## Landscape Referral Response

Application Number:	DA2022/2081
Date:	22/02/2023
Proposed Development:	Change of use and construction of a golf club house and associated facilities.
Responsible Officer:	Maxwell Duncan
Land to be developed (Address):	Lot 2742 DP 752038 , 292 Condamine Street NORTH MANLY NSW 2100 Lot 2742 DP 752038 , 292 Condamine Street NORTH MANLY NSW 2100

Fig. 1 - Tree location plan from the Arborist's Report

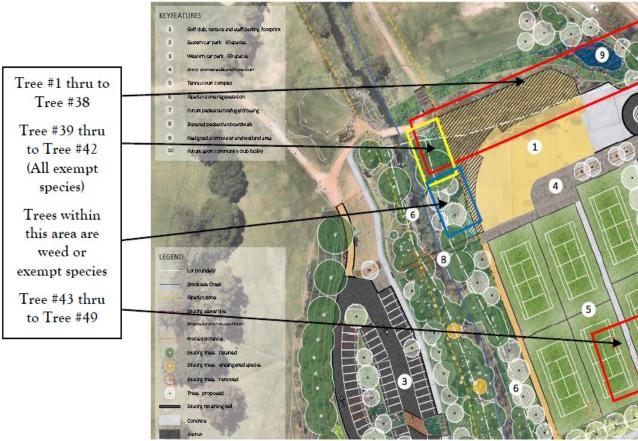
The Arborist's Report locates the trees on a plan in general location rather than identifying each tree. (Fig. 1 below)

The trees should be identified on the Survey Plan so that each tree is identified via their corresponding number in the Report. The trees' Tree Protection Zones and Structural Root Zones are also required to be shown on the plan to enable assessment of impacts of the proposed works and to clearly identify the trees to be removed and trees to be retained as applies to this application.

Fig. 2 - Surveyed tree location indicated on the Demolition Plan.

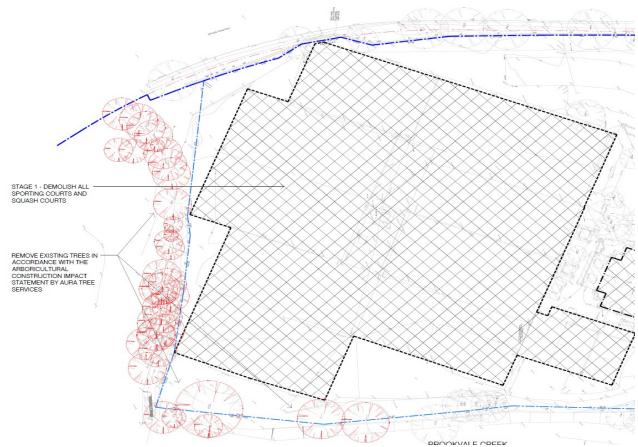
The Demolition Plan shows trees to be removed from a detailed a Survey Plan. (Fig. 2 below)

The Arborist's report appears to refer to trees being removed adjacent to the existing tennis courts whereas the Demolition Plan does not identify these trees to be removed.
